36/1-05B 2801 Linden Lane
MP Site # 36/1 National Park Seminary

LIGHTS / INTERPRETIVE
SIGNAGE

HISTORIC PRESERVATION COMMISSION STAFF REPORT

| PROPOSAL: | Landscape Plan including lighting and signage. | RECOMMENDATION: | Conditional Approval |

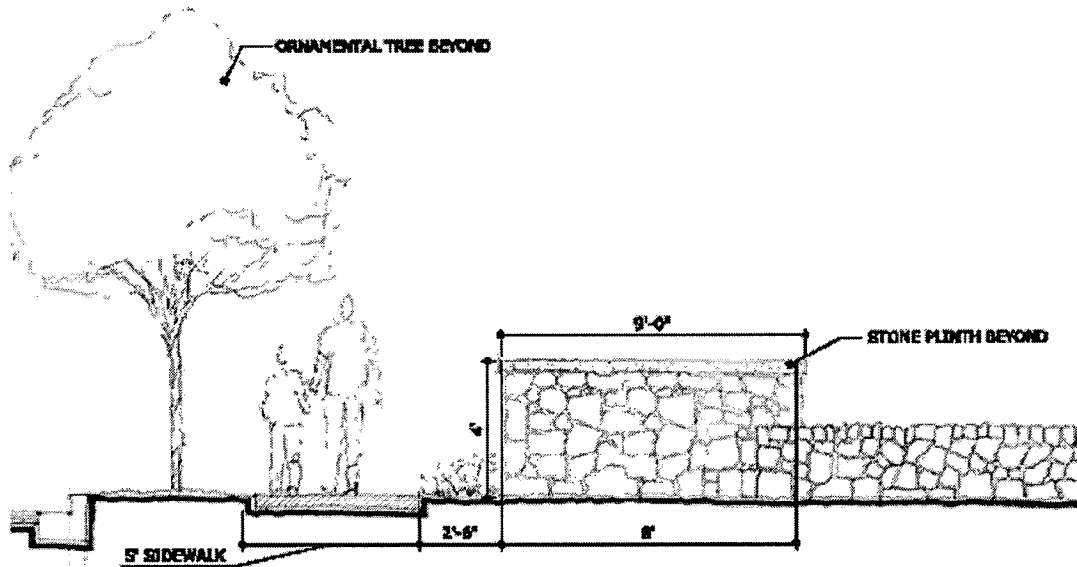
Why do the street trees have to be set at such regular intervals? Especially on the historic side?

Explain the tree selections to me.

Why Type A along Ludlow Lane?
